Re: Traffic Impact Analysis (TIA) Report - Addendum
Port Marigny Site
DE Project No. 576-1000-01

We have reviewed the Addendum to the Traffic Impact Analysis developed by Hall Planning & Engineering, Inc. dated November 5, 2015 for the above referenced site. Below are comments or suggestions to consider for this addendum.

PM TRAFFIC VOLUMES & LEVELS OF SERVICE
 2015 LOS (2025 LOS) → 2015 VOLUME (2025 VOLUME)

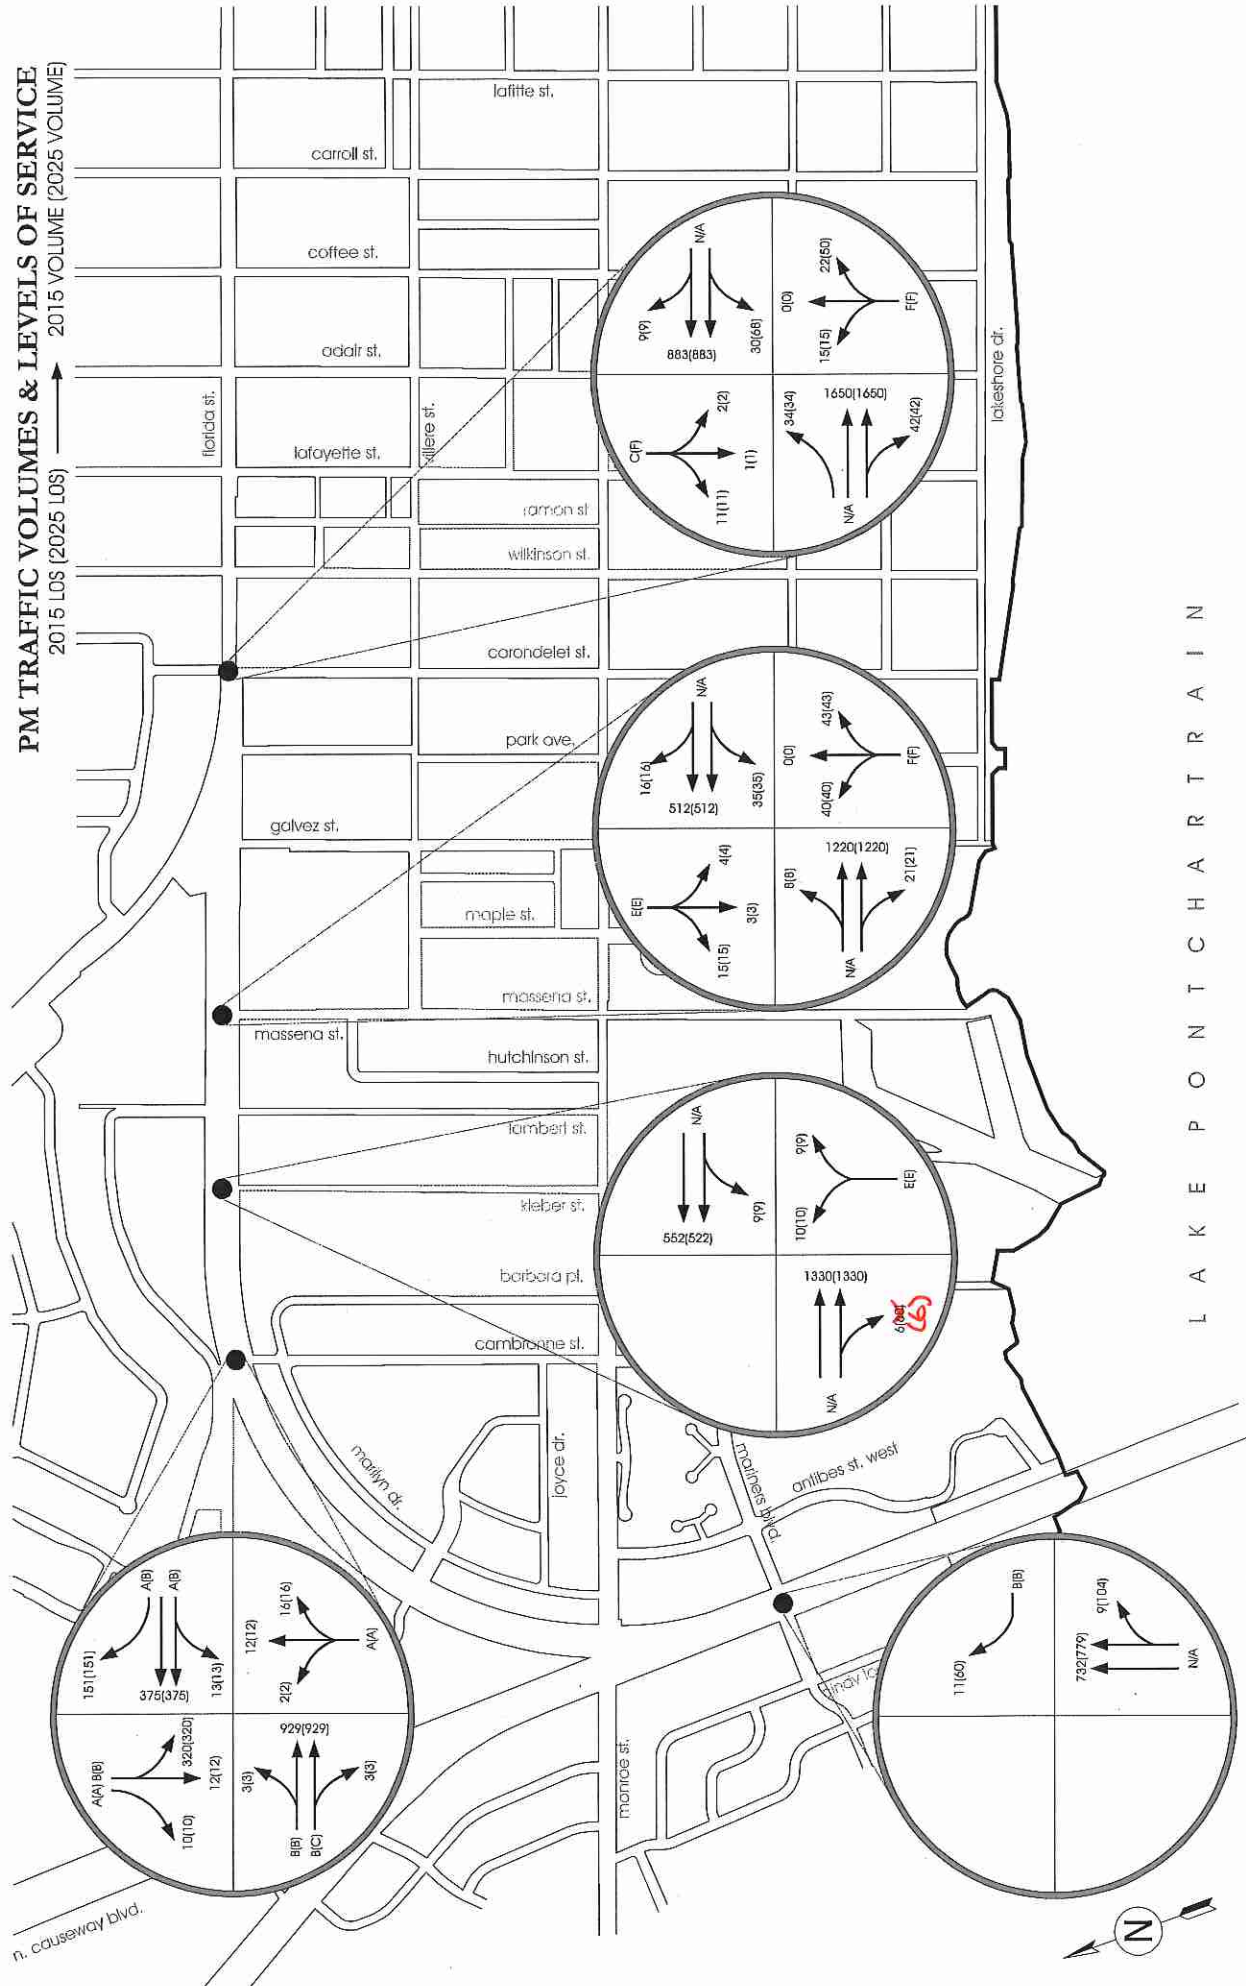
1. At the Monroe Street and E. Causeway Approach intersection, the future pm traffic volume (36 vehicles) should be verified. Considering an existing volume of 25 vehicles this is only an additional 11%. The development distribution has this percentage at 17.5%.

2. At the Monroe Street and E. Causeway Approach intersection, what signal timings were utilized for both the existing and future conditions?
3. At the Monroe Street and E. Causeway Approach intersection, the report should mention the drop in LOS for the southbound approach. At this intersection (from 2015 to 2025 with no remediation measures in place), the southbound left turn dropped from a LOS D to E and the right turn dropped from a LOS E to F. Furthermore the report should also depict how this was reverted back to the original LOS once the improvements (westbound left turn lane) are in place and the reasoning behind this change back to the original LOS.

AM TRAFFIC VOLUMES & LEVELS OF SERVICE

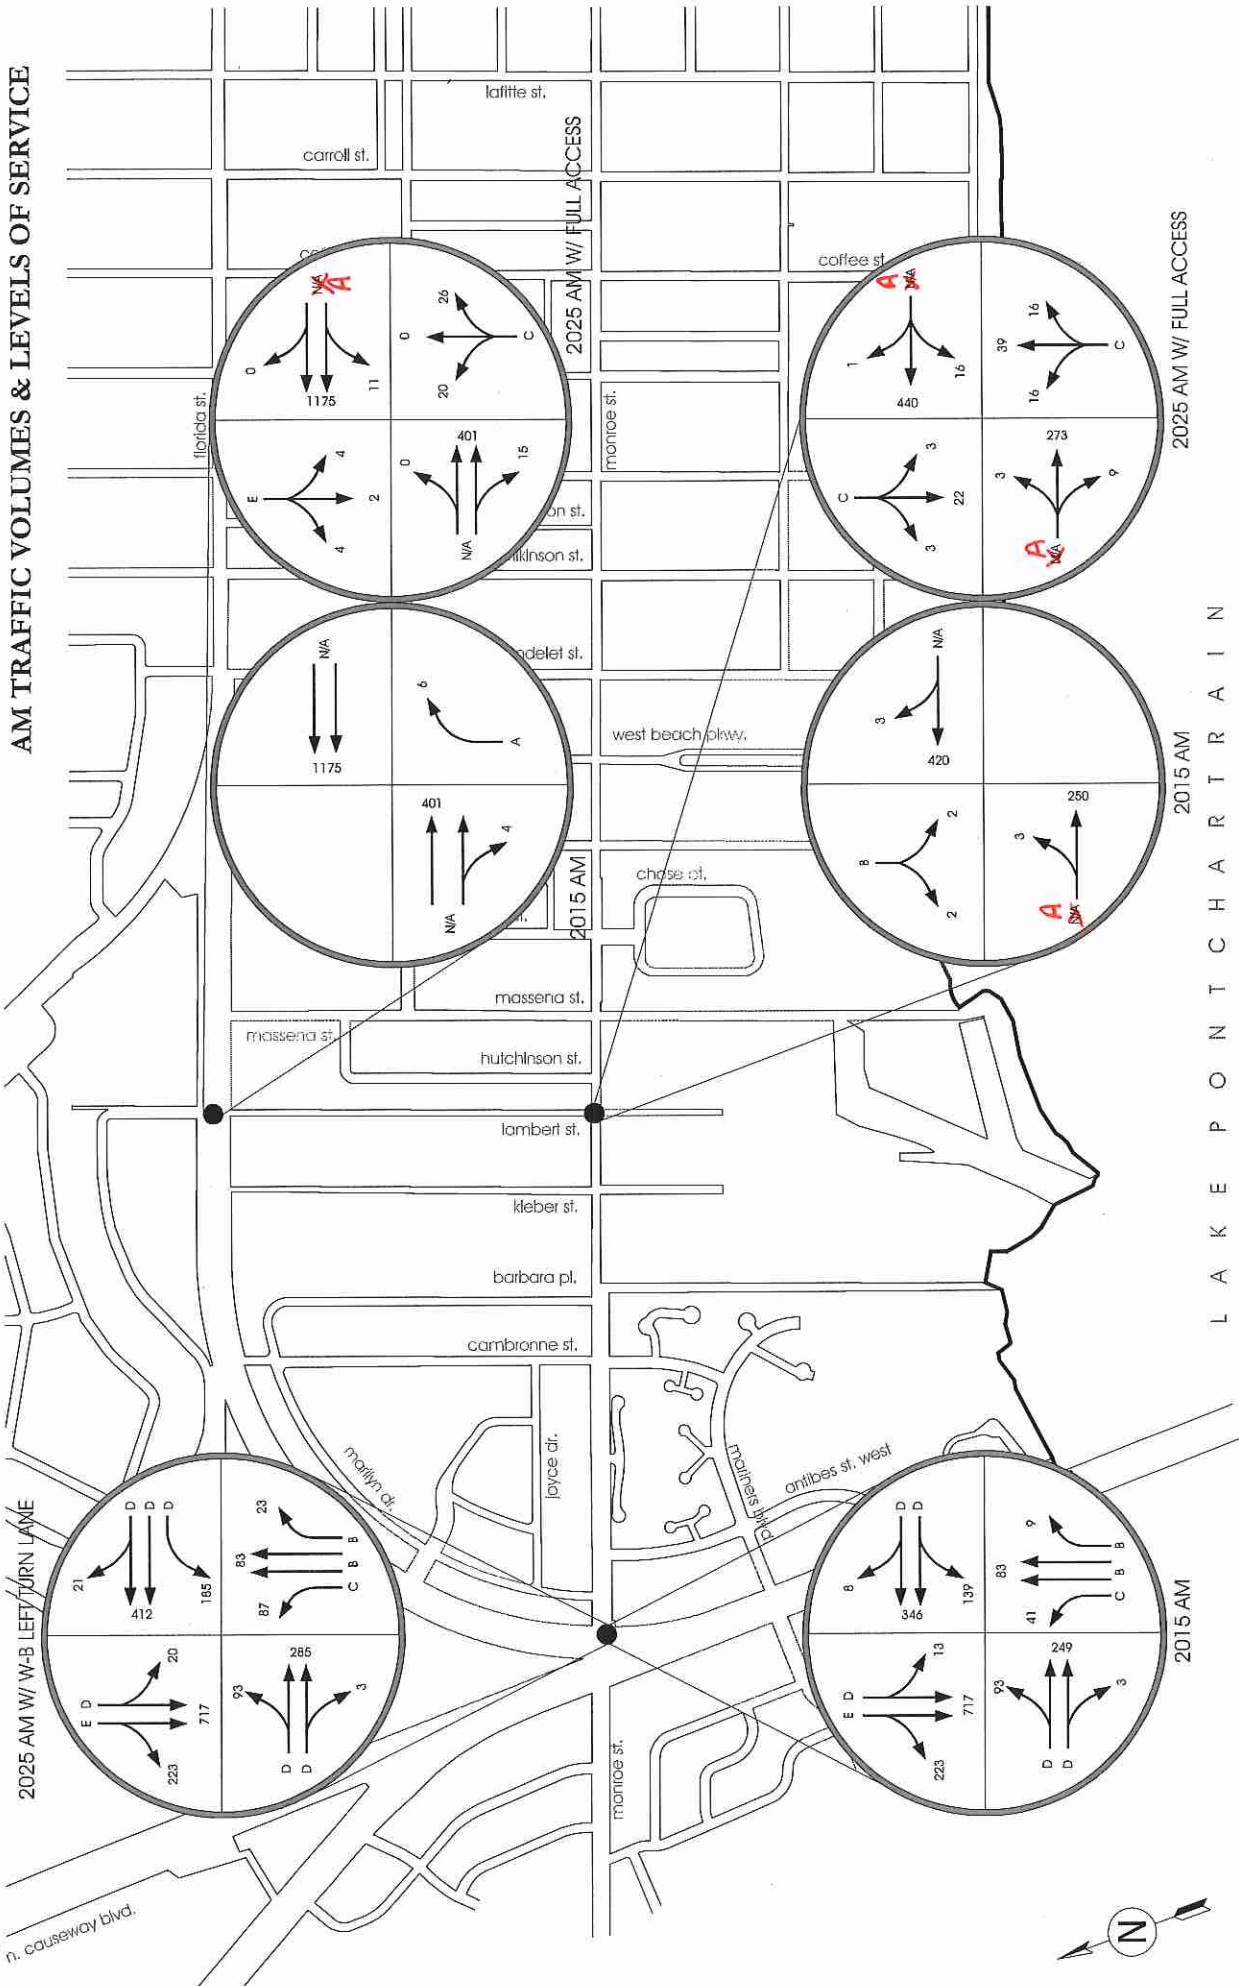
6. The the Syncro output for Lambert Street should be reviewed. For example, there is no 2015 am Syncro output for this intersection.
7. Section V – Summary notes that “providing full access at the intersection of Lambert Street with the E. Causeway Approach is recommended.” Will the proposed improvements call for a traffic signal system at this intersection? Will one be needed to provide for an acceptable LOS? Currently there is a LOS F for the northbound approach at this intersection at 2025 pm.

PM TRAFFIC VOLUMES & LEVELS OF SERVICE

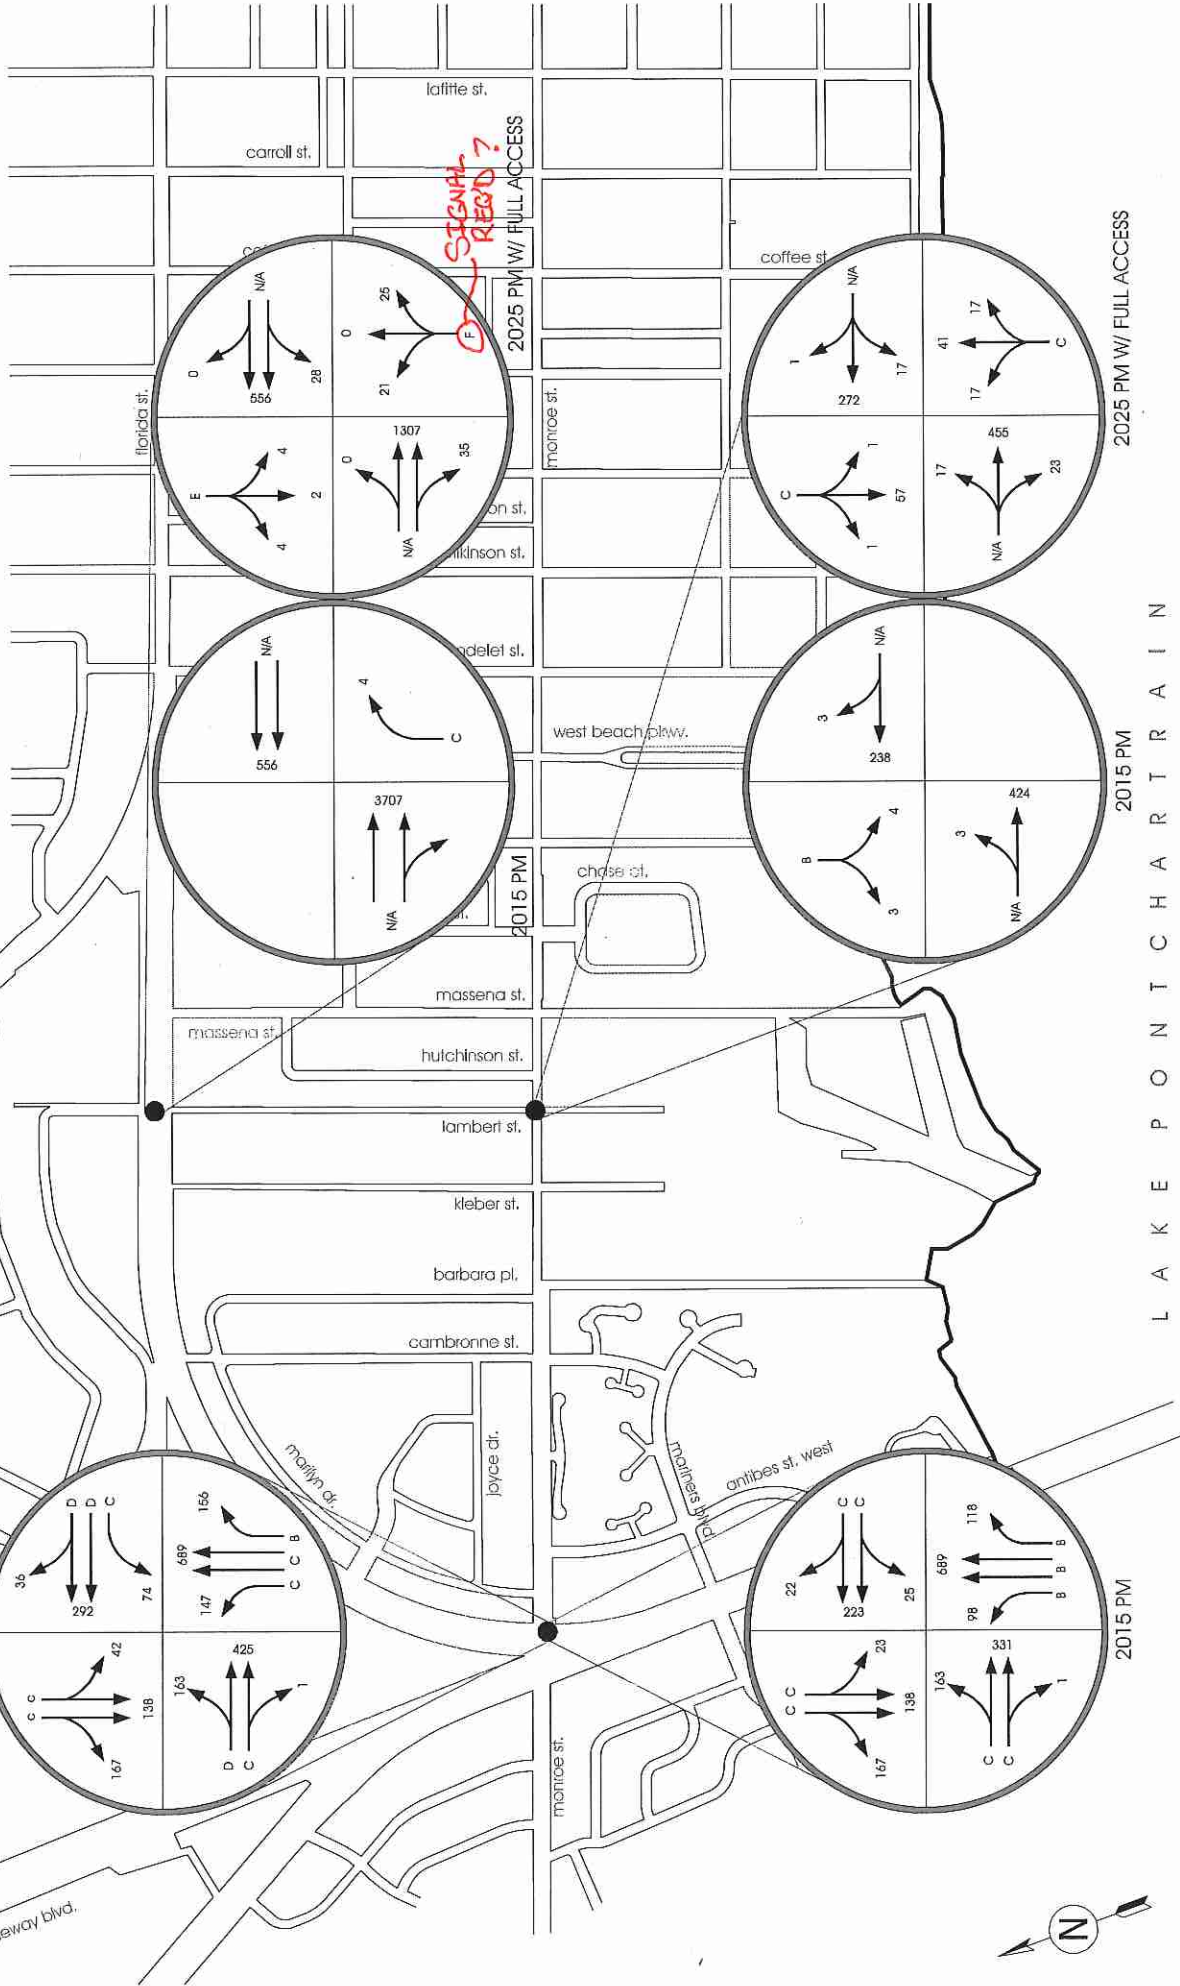
SIGNAL REQ'D?
